LETTER OF TRANSMITTAL

Date: March 11, 2004
Subject: 606 E. Ave San Juan
Geotechnical Review

→ SUBJECT: Preliminary Geotechnical Investigation of Distressed Residential Property, 606 E. Avenida San Juan, San Clemente, California

GEOTECHNICAL MAP
1"=20'

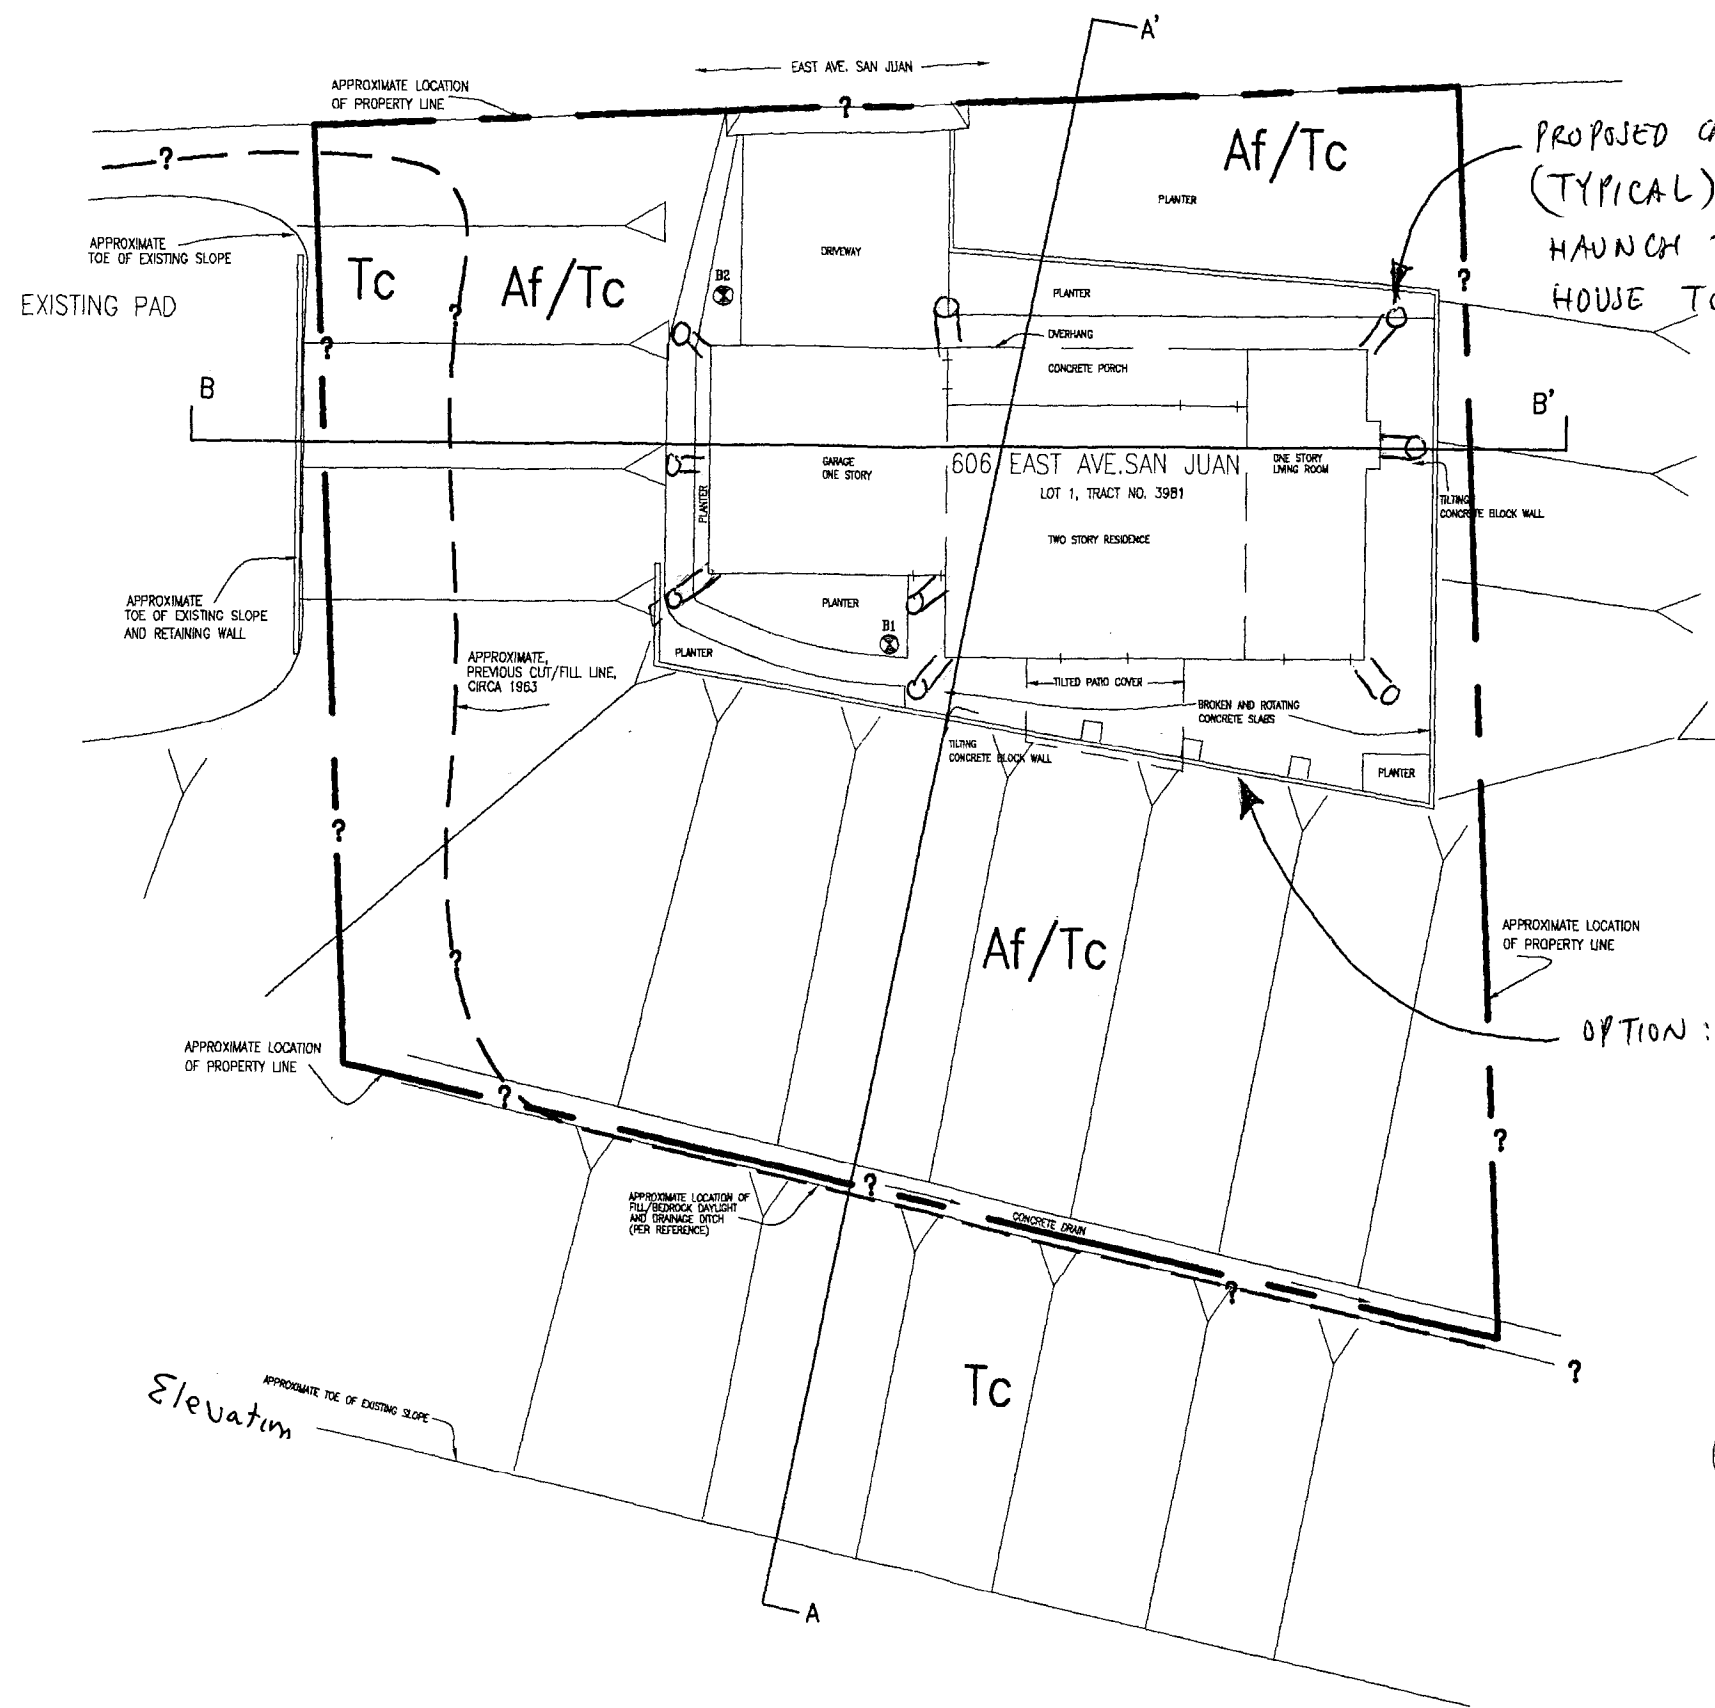
No stability Calculations
Deeper boring needed to insure that No Qls present Additional Lateral Force will be needed

Stability Cals on both faces

different with one row of caissons

FIGURE 6

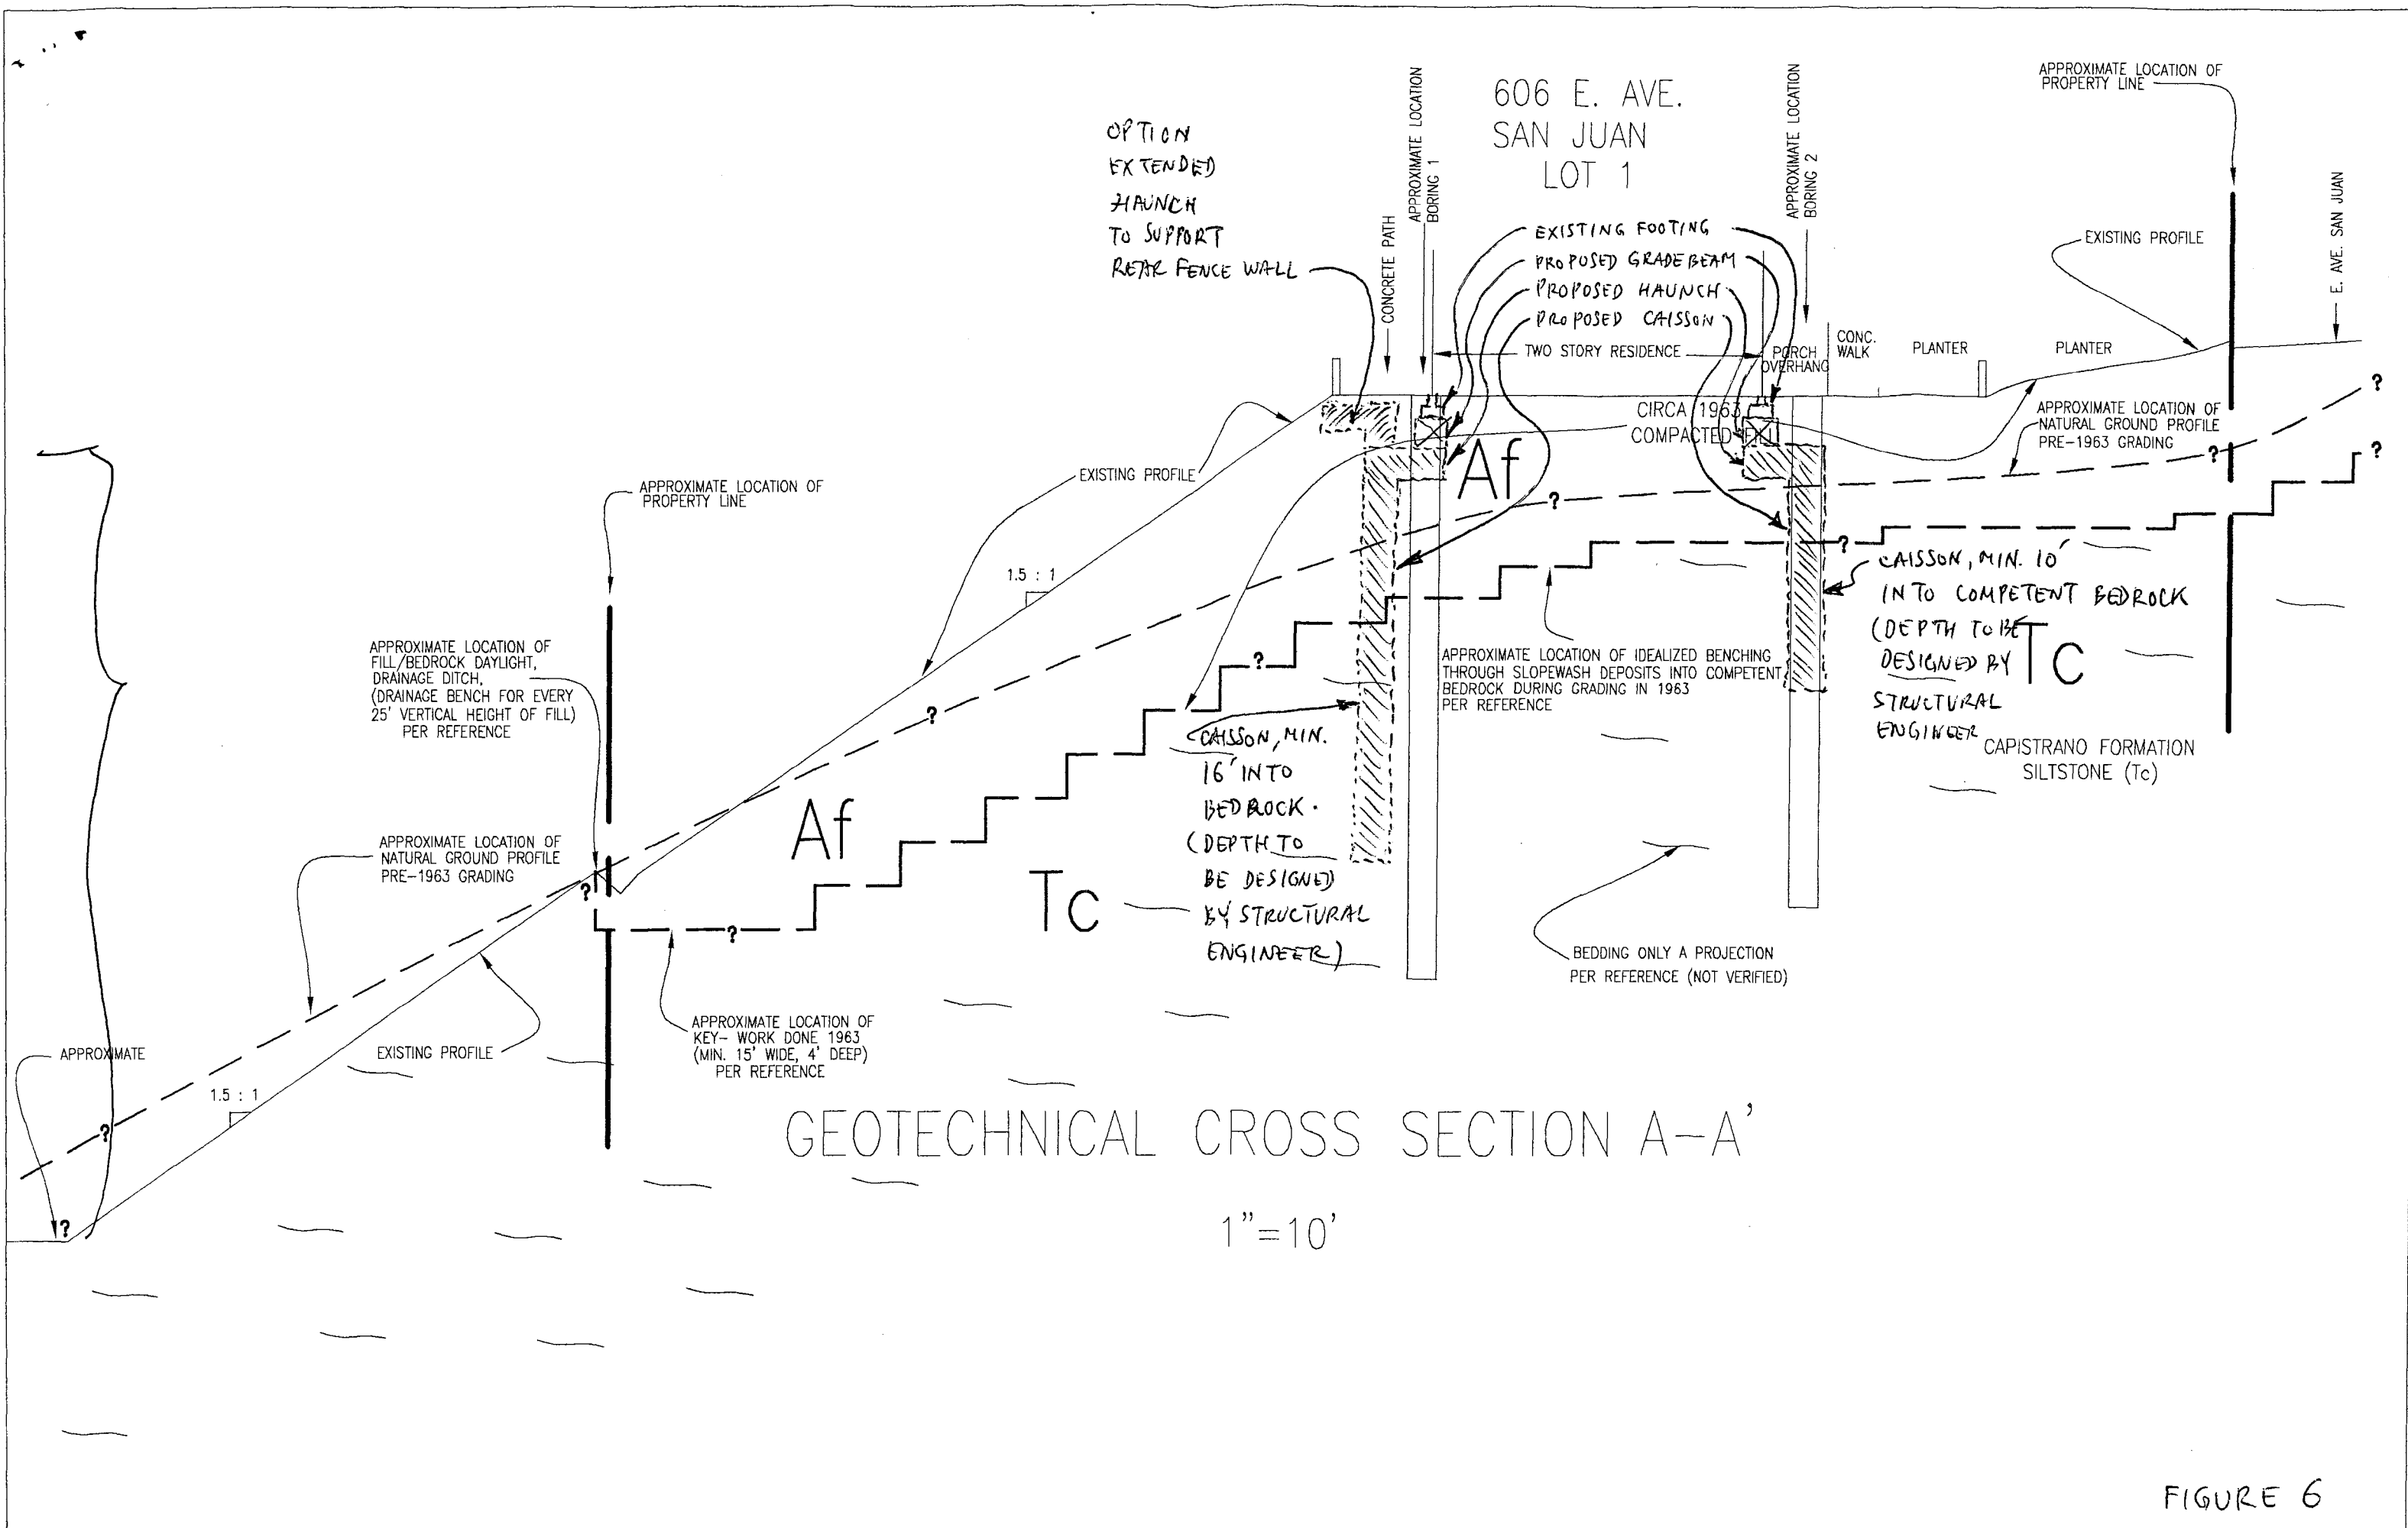
Need copy original grading map
Slope Stability
